FINAL

Record of Decision Amendment No. 1 Operable Unit 1 Area 6

NAS Whidbey

Oak Harbor, Washington

From comment #12:

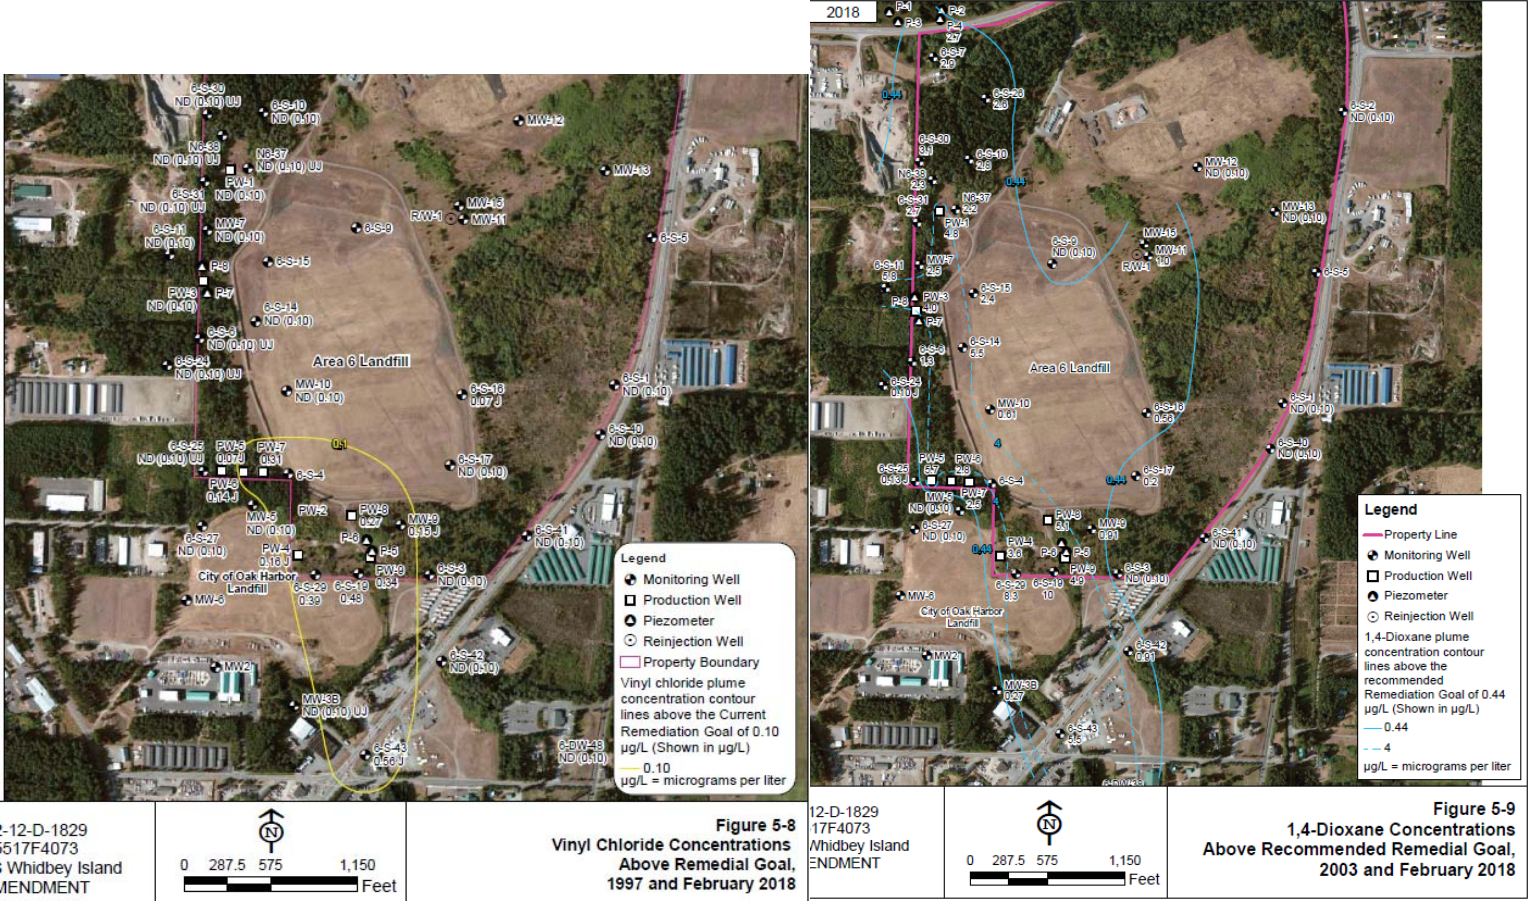
Comment # (Commenter)	Section / Page / Lines	EPA Comment	Navy Response	EPA Response Evaluation	Navy Response to EPA Evaluation / EPA Response
		<p>alternatives appears to discuss a MODFLOW analysis that evaluated the relative timeframes between achieving final cleanup goals by continuing extraction and treatment versus switching to MNA. According to OSWER Directive 9200.4-17P, “MNA should be selected only where it meets all relevant remedy selection criteria, and where it will meet site remediation objectives within a timeframe that is reasonable compared to that offered by other methods.” Absent a discussion of whether the criteria for selecting MNA has been conducted, it is not clear the Navy can select it as a remedial technology. Rather than arbitrarily assume a transition point, the Navy should conduct an alternatives analysis that evaluates active treatment technology remedies compared to hybrid remedies that include the transition to MNA so that the balancing criteria can effectively assess the performance of the different alternatives to each other. Additionally, since it is unlikely that the “trigger levels” for all COCs identified in this ROD Amendment will be achieved simultaneously, the criteria for the transition from extractions and treatment to MNA may actually occur is insufficiently defined. Although transitions points for all COCs are presented in Table 6-5, the description of the selected remedy in Section 8.2 appears to only discuss concentrations of 1,4-dioxane as a transition point.</p> <p>Absent an MNA analysis consistent with EPA policy and guidance and without full consideration of the relative merits of including MNA as a remedy component relative to alternative that do not include it as a technology, the Navy cannot select it as a component of the remedy for this ROD Amendment. The Navy may wish to state an intent to consider whether MNA represents a viable remedial alternative when certain groundwater COC concentrations are attained. However, even if such analysis indicates that MNA represents a viable technology, it can only be selected through an additional ROD Amendment.</p>	<p>2) Insitu groundwater treatment which applies to Alternatives 3 and 4</p> <p>All evaluated alternatives are integrated remedies with an active treatment phase and a passive (natural attenuation) phase. The modeling was used to estimate the time for transition from the active phase to the passive phase. The modeling was also used to evaluate the time to reach RGs under the passive phase, once the active phase had been terminated. These metrics were used in the evaluation.</p> <p>The following will be added to Section 7.1, Alternatives 2, 5, and 6:</p> <p>The western and southern plants would be operated until dissolved COC concentrations reach 3 times the RGs, as discussed in Section 8.4 Modeling predictions indicate western system operation will reach 3 times the RG for both TCE and 1,4-dioxane much sooner than the southern system.</p>	<p>and substantial downgradient transport of contaminants from the original source area.”</p> <p>“At this time, natural attenuation is a less clearly viable alternative to pump and treat for meeting remediation objectives in the western contaminant plume.”</p>
